TENANT IMPROVEMENT PLAN CHECK COMMENTS

PLAN CHECK NO:	10174363		
PROJECT ADDRESS:	4 E Hutton Center Dr Unit# 370		
PLAN CHECK ENGINEER:	Mazarji, Zac	TEL: 714	647-5831
		FAX: 714	647-5897
TYPE OF CONSTRUCTION:	I A, SPK		
OCCUPANCY CLASSIFICATION(S):	B		
PLAN CHECK DATES:		REMARKS/RECHECK ITEMS:	
APPLICATION	2/9/2012	_____	
INITIAL REVIEW	2/10/2012	_____	
EXPIRATION	8/7/2012	_____	
RECHECKS:	1.	PROJECT APPLICANT CONTACT PERSON:	
	2.	Fraser McClellan	
	3.	TEL:	(714)307-6883
		FAX:	(714)897-5952
VALUATION:	\$117,800.00	EMAIL:	Fraser@fmacorp.com
FLOOD ZONE:	X-0602320278J

TENANT IMPROVEMENT PLAN CHECK COMMENTS

Tenant Improvements for:
HFS CONSULTING
 Suite Expansion & Remodel
 Suite 370

TYP. CEILING SUSPENSION N.T.S. 9

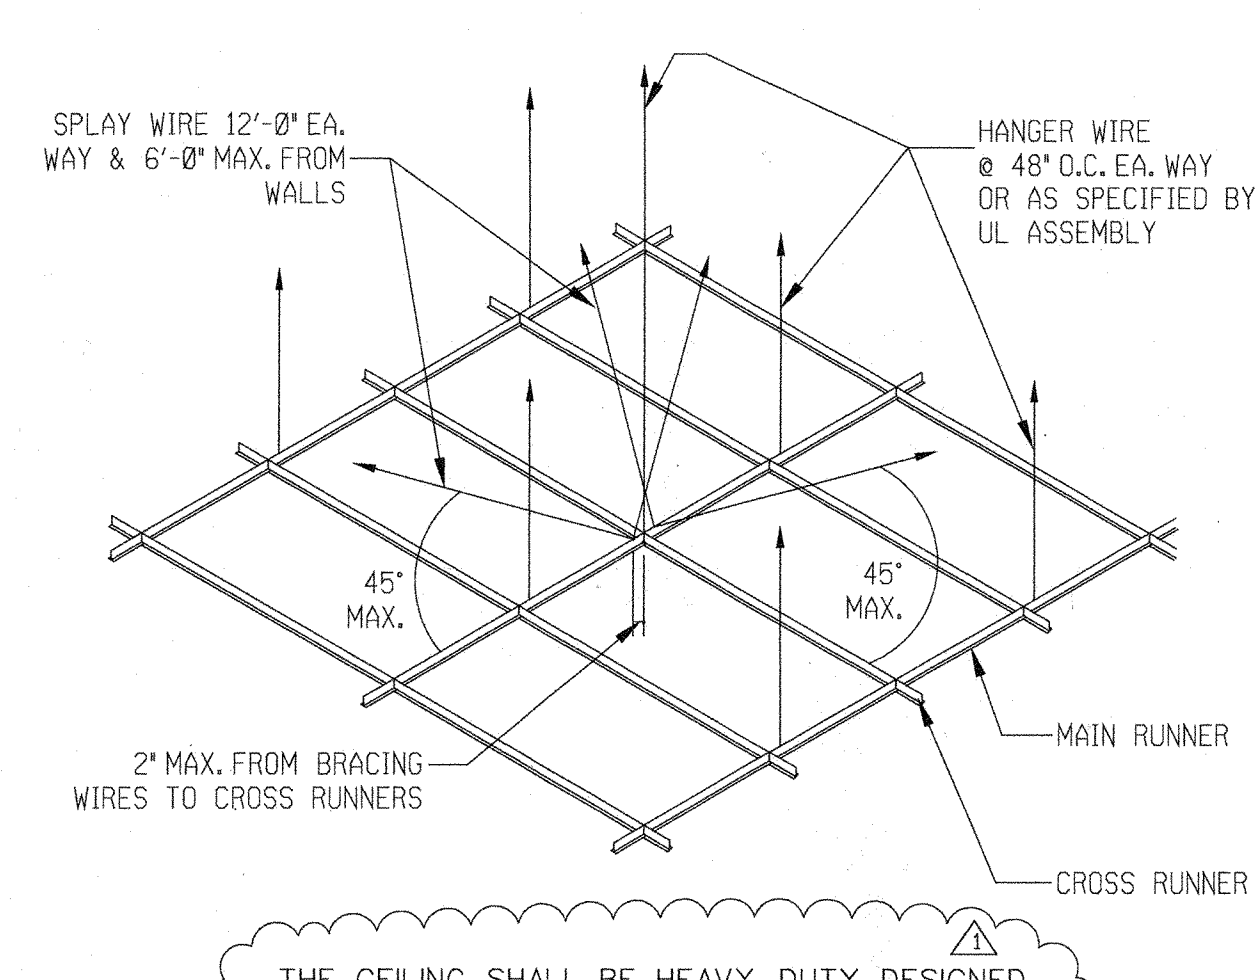
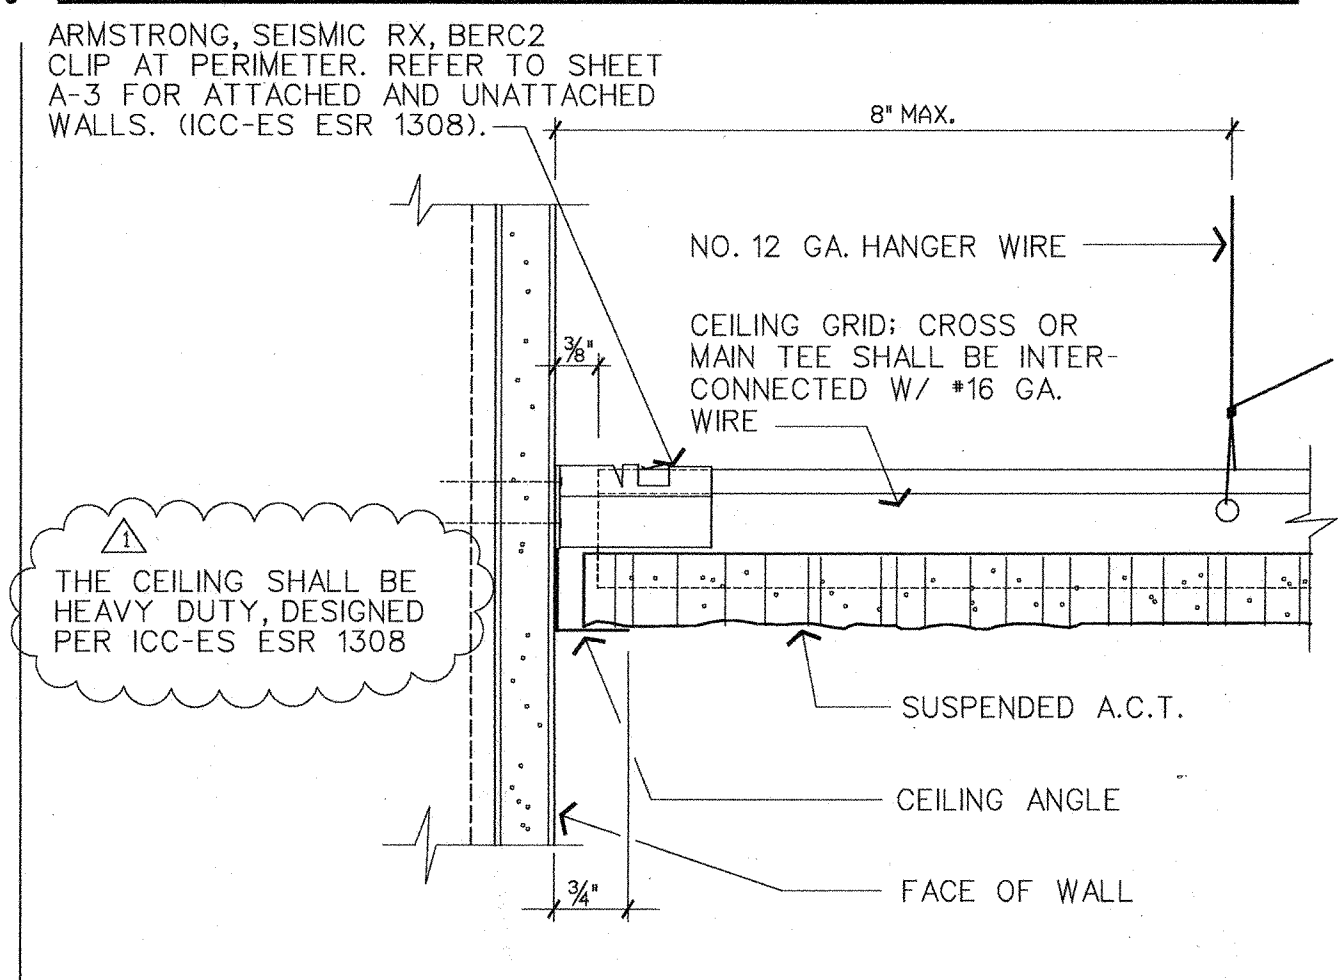
19. In lieu of providing structural calculations for new suspended ceiling, note ICC Research Report Number on the drawings for the suspended ceiling system. (ICC Report Number 1308) *ADDED TO CEILING DETAILS 9 AND 10*
